December 26, 2016

**RE: Pilgrim Nuclear Power Station, Plymouth, Massachusetts**

## APPENDIX A

Photos: Pilgrim Nuclear Power Station on November 18, 2016

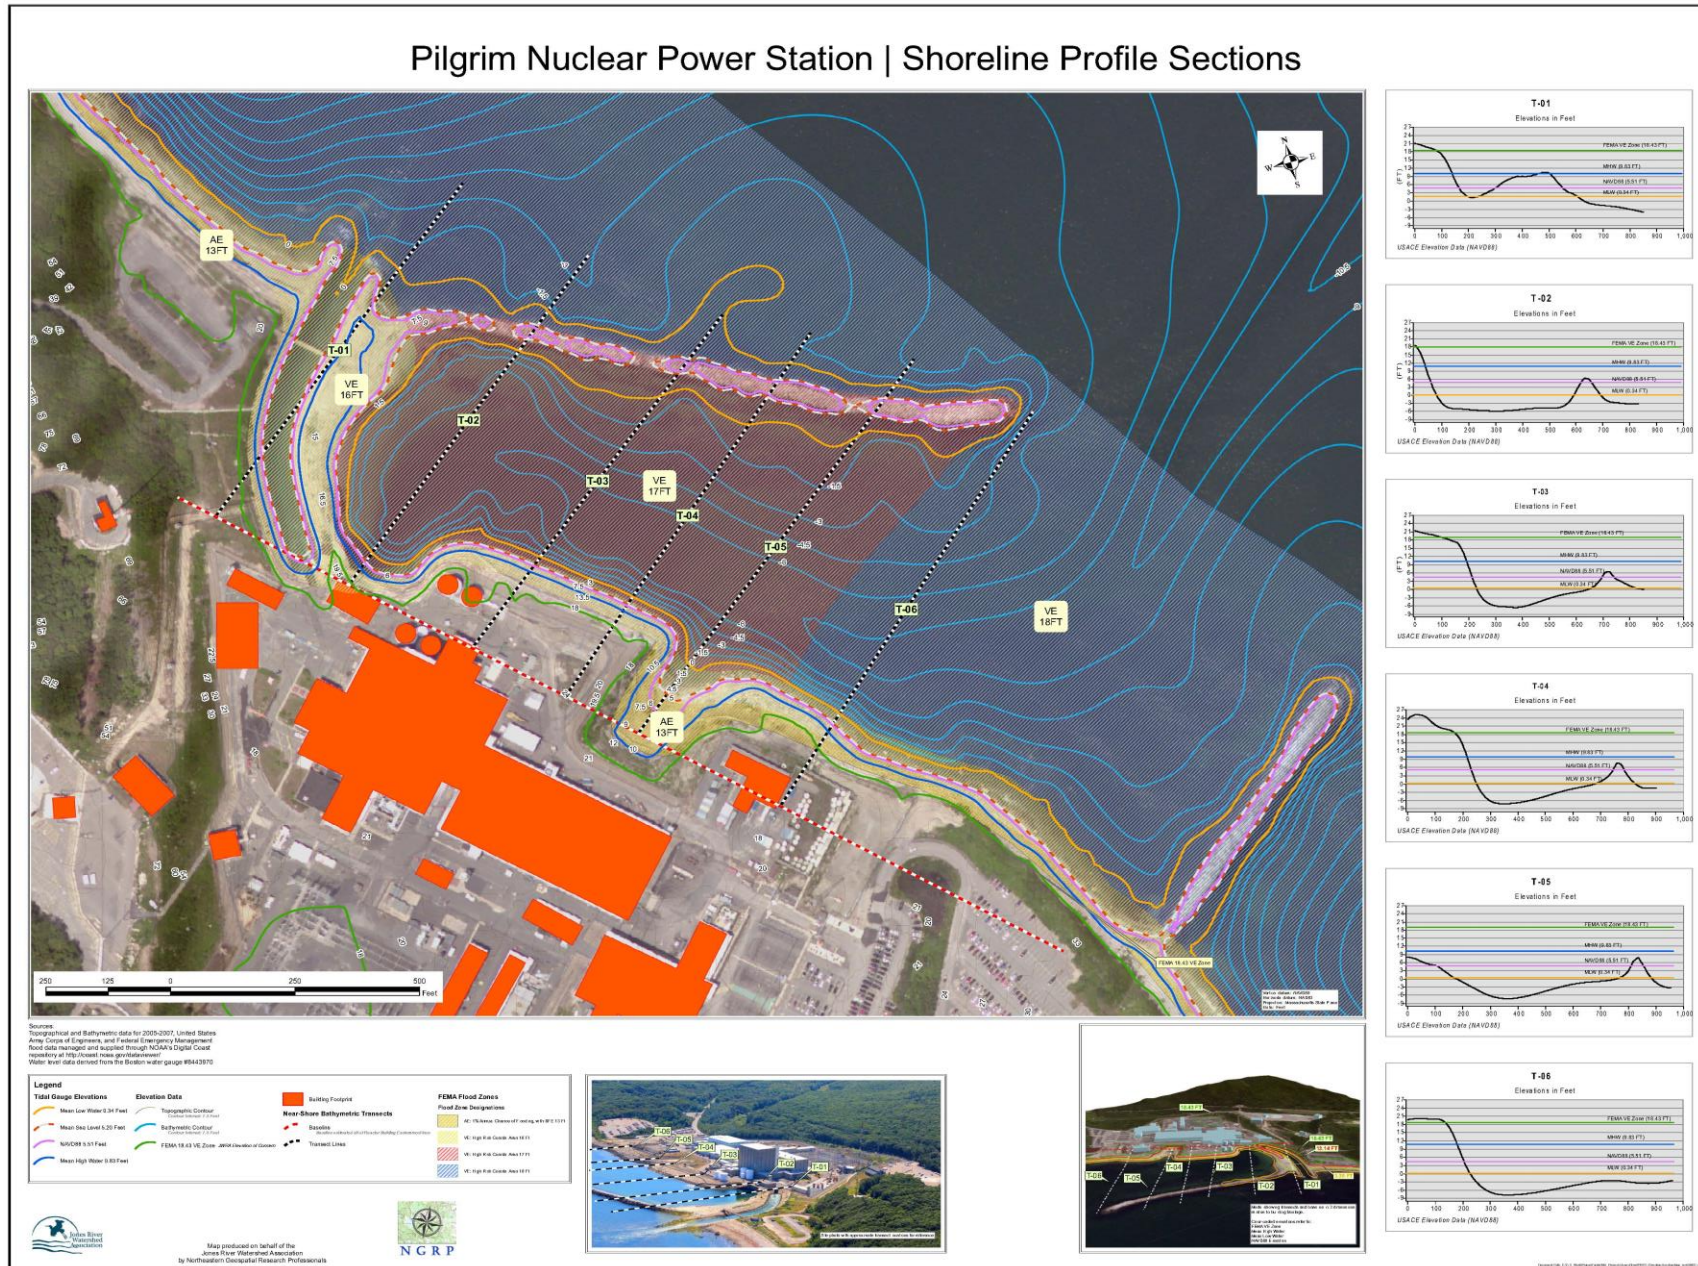
We are now bringing to your attention two aerial photographs taken in November 2016 (Appendix A), which show that NGRP's site maps are accurate (Appendix B). These photos validate the LiDAR data used by NGRP to generate the site maps – the jetty in the photos are over-washed with seawater in the same locations depicted as lower elevations in the site maps, despite Entergy's claims that the PNPS elevations are higher. It's important to note that the photos, based on tidal marks and rack lines, are of the PNPS site during moderate wind and weather conditions and likely after high tide (Appendix C). During just a Category 1 storm, both the easterly revetment and the southerly jetty would be inundated.

Estimated to be just after a 12 ft. high tide and with moderate wind conditions (6-14 mph) from NNE
